SERVICE BULLETIN

ENGINE — HIGH PRESSURE (HP) COMPRESSOR — STAGE 3 TO 8 COMPRESSOR
DRUM — INTRODUCTION OF DAMPER WIRES FOR STAGES 6 TO 8

V2500 Series 72-0642

V2500-ENG-72-0642

HIGH PRESSURE (HP) COMPRESSOR STAGES 3 TO 8 ROTOR DISC ASSEMBLY WITHOUT
HP COMPRESSOR STAGES 6 TO 8 DAMPER WIRES INSTALLED
FIGURE 1

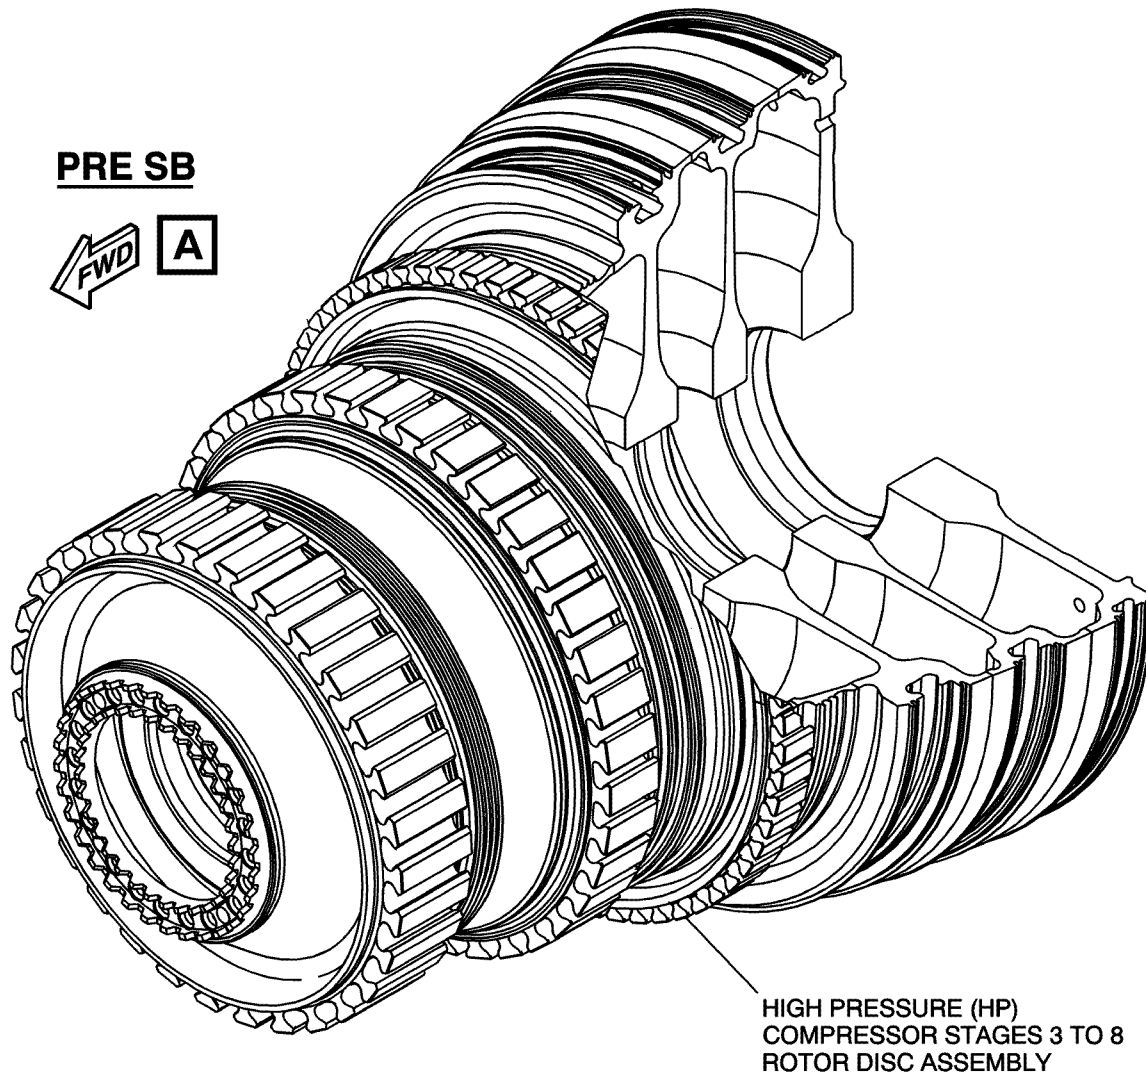
- B. Disassemble the HP compressor assembly (Refer to the Reference 3, Engine Manual, Chapter/Section 72-41-00).
 - C. Disassemble the HP compressor rotor assembly (Refer to the Reference 3, Engine Manual, Chapter/Section 72-41-10 and to Figure 1 of this Service Bulletin).

- (1) Remove the HP compressor stages 6, 7 and 8 blades from the HP compressor stages 3 to 8 rotor disc assembly.
 - D. Assemble the HP compressor rotor assembly (Refer to the Reference 3, Engine Manual, Chapter/Section 72-41-10 and to Figure 2 of this Service Bulletin).

HIGH PRESSURE (HP) COMPRESSOR STAGES 3 TO 8 ROTOR DISC ASSEMBLY WITH
HP COMPRESSOR STAGES 6 TO 8 DAMPER WIRES INSTALLED
FIGURE 2, SHEET 1

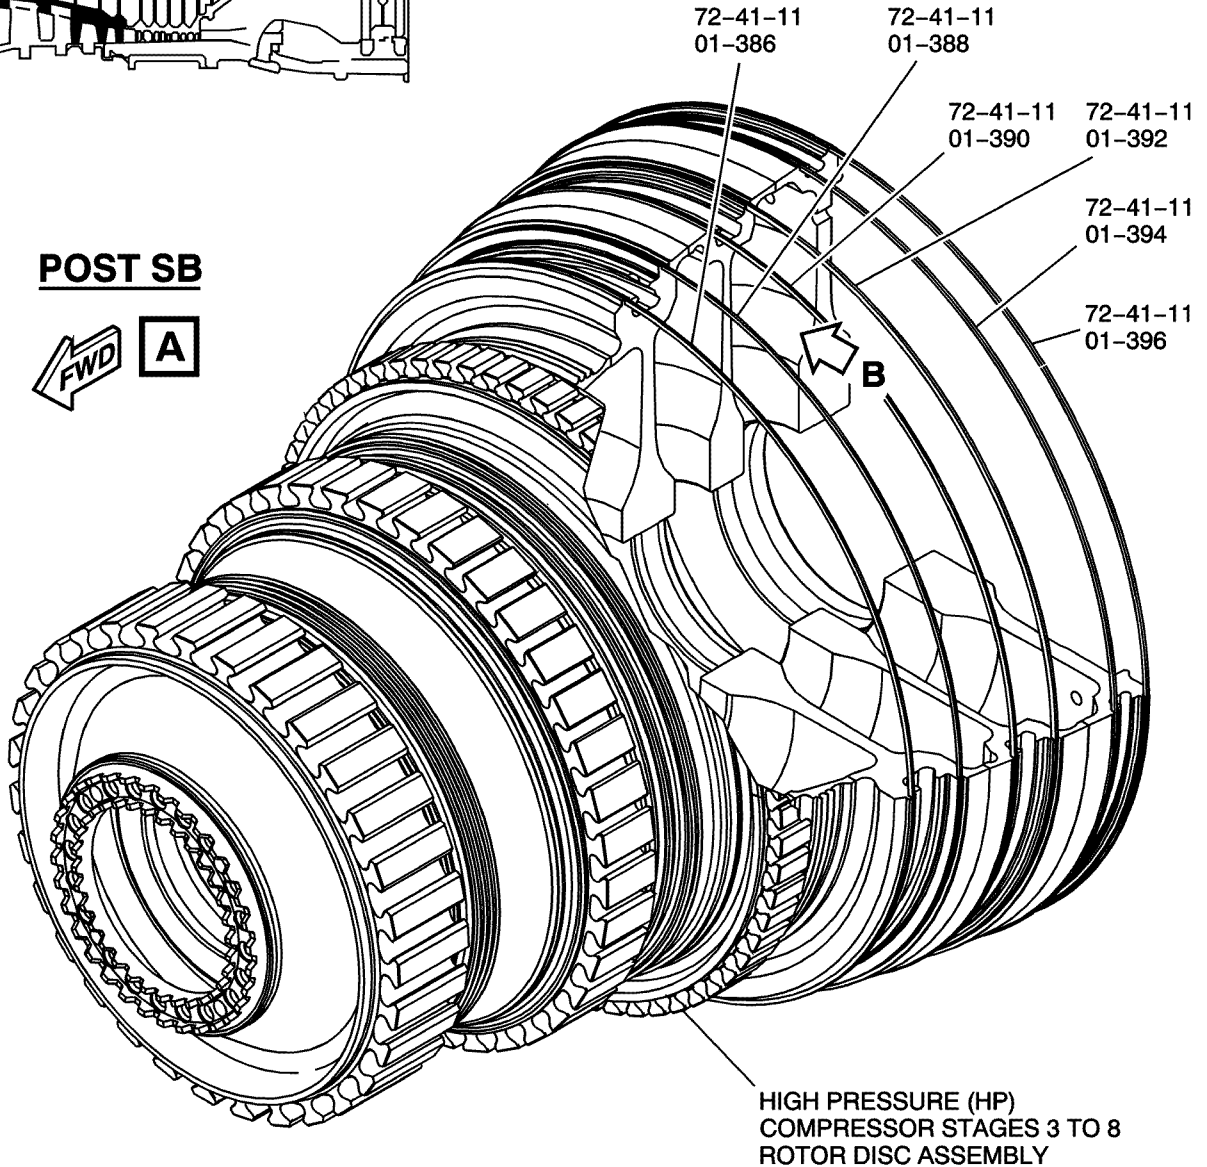
- (1) Install the six HP compressor stages 6 to 8 damper wires (72-41-11, 01-386 to 72-41-11, 01-396).
 - (a) Install the new HP compressor Stage 6 Front Seal Wire, PN 6A1146 (72-41-11, 01-386), in the HP compressor stage 6 front damper wire groove of the HP compressor stages 3 to 8 rotor disc assembly.

- 1 Make sure that the HP compressor Stage 6 Front Seal Wire, PN 6A1146 (72-41-11, 01-386) is installed in the correct damper wire groove of the HP compressor stages 3 to 8 disc assembly. Refer to Figure 2, Sheet 1.

- 1 Make sure that the HP compressor Stage 6 Rear Seal Wire, PN 6A1147 (72-41-11, 01-388) is installed in the correct damper wire groove of the HP compressor stages 3 to 8 disc assembly. Refer to Figure 2, Sheet 1.

- 1 Make sure that the HP compressor Stage 8 Front Seal Wire, PN 6A7388 (72-41-11, 01-394) is installed in the correct damper wire groove of the HP compressor stages 3 to 8 disc assembly. Refer to Figure 2, Sheet 1.

- 1 Make sure that the HP compressor Stage 8 Rear Seal Wire, PN 6A7389 (72-41-11, 01-396) is installed in the correct damper wire groove of the HP compressor stages 3 to 8 disc assembly. Refer to Figure 2, Sheet 1.

- 1 Make sure that the HP compressor Stage 7 Front Seal Wire, PN 6A7386 (72-41-11, 01-390) is installed in the correct damper wire groove of the HP compressor stages 3 to 8 disc assembly. Refer to Figure 2, Sheet 1.

- 1 Make sure that the HP compressor Stage 7 Rear Seal Wire, PN 6A7387 (72-41-11, 01-392) is installed in the correct damper wire groove of the HP compressor stages 3 to 8 disc assembly. Refer to Figure 2, Sheet 1.

INSTALLATION OF THE HIGH PRESSURE (HP) COMPRESSOR STAGES 6 TO 8 DAMPER WIRES
FIGURE 2, SHEET 2

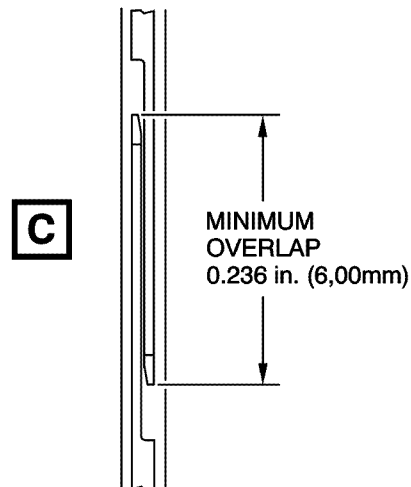
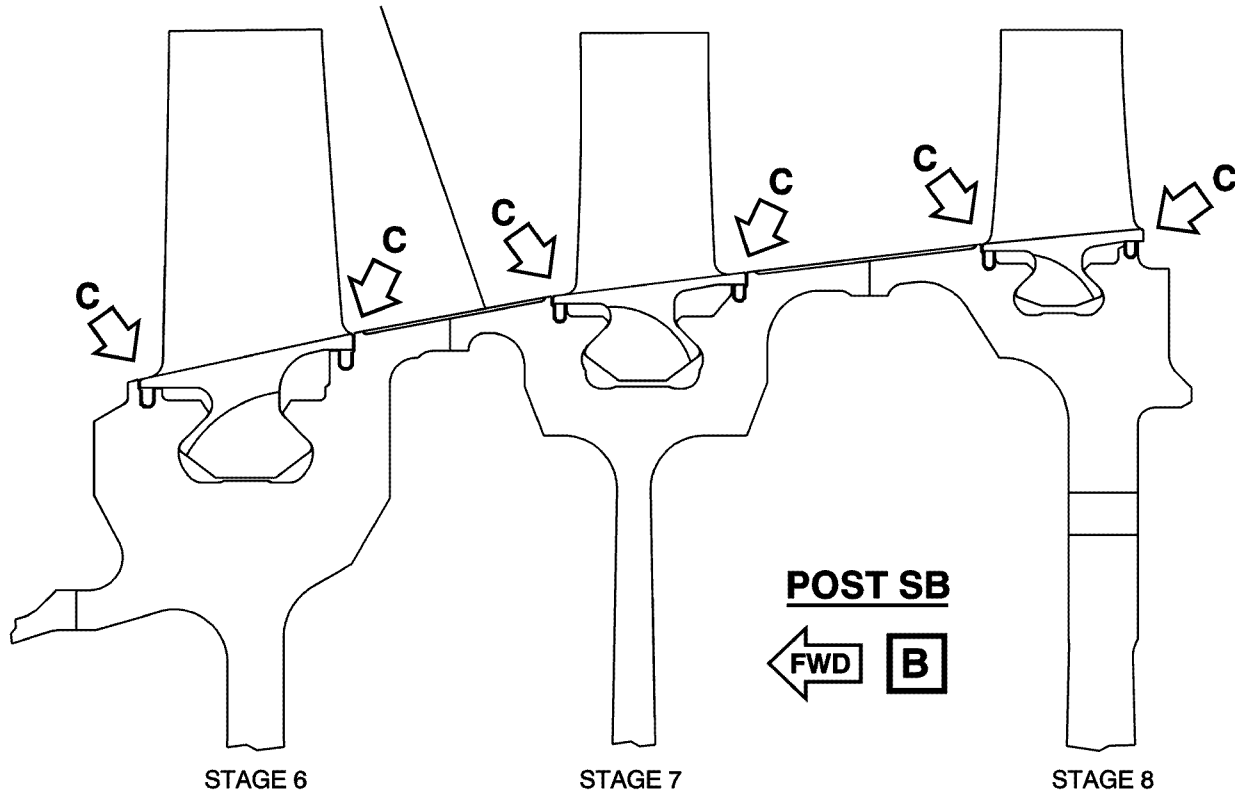
- 2 Make sure that the ends of the HP compressor Stage 6 Front Seal Wire, PN 6A1146 (72-41-11, 01-386) overlap by at least 0.236 in. (6.00 mm). Refer to Figure 2, Sheet 2.

- 2 Make sure that the ends of the HP compressor Stage 6 Rear Seal Wire, PN 6A1147 (72-41-11, 01-388) overlap by at least 0.236 in. (6.00 mm). Refer to Figure 2, Sheet 2.

- 3 Make sure that the overlap of the HP compressor Stage 6 Rear Seal Wire, PN 6A1147 (72-41-11, 01-388) is positioned 180 degrees from the overlap of the HP compressor Stage 6 Front Seal Wire, PN 6A1146 (72-41-11, 01-386).

- 2 Make sure that the ends of the HP compressor Stage 8 Front Seal Wire, PN 6A7388 (72-41-11, 01-394) overlap by at least 0.236 in. (6.00 mm). Refer to Figure 2, Sheet 2.

- 2 Make sure that the ends of the HP compressor Stage 8 Rear Seal Wire, PN 6A7389 (72-41-11, 01-396) overlap by at least 0.236 in. (6.00 mm). Refer to Figure 2, Sheet 2.

- 3 Make sure that the overlap of the HP compressor Stage 8 Rear Seal Wire, PN 6A7389 (72-41-11, 01-396) is positioned 180 degrees from the overlap of the HP compressor Stage 8 Front Seal Wire, PN 6A7388 (72-41-11, 01-394).

- 2 Make sure that the ends of the HP compressor Stage 7 Front Seal Wire, PN 6A7386 (72-41-11, 01-390) overlap by at least 0.236 in. (6.00 mm). Refer to Figure 2, Sheet 2.

- 2 Make sure that the ends of the HP compressor Stage 7 Rear Seal Wire, PN 6A7387 (72-41-11, 01-392) overlap by at least 0.236 in. (6.00 mm). Refer to Figure 2, Sheet 2.

NOTE: THE OVERLAP ON THE FRONT
DAMPER WIRE TO BE POSITIONED
180° FROM THE OVERLAP ON THE
REAR DAMPER WIRE.

ENGINE MAJOR FLANGES
FIGURE 3

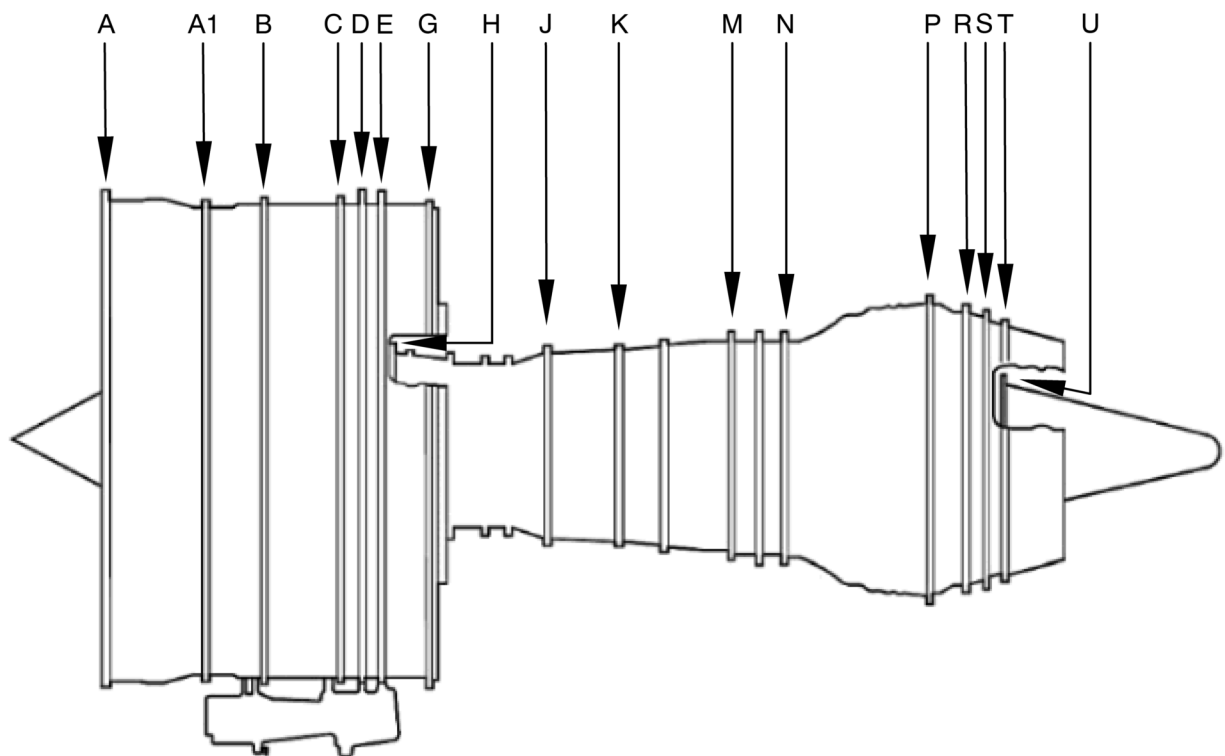
visit. A “major mating engine flange” is considered flanges H through P. For location of engine flanges, refer to Figure 3.
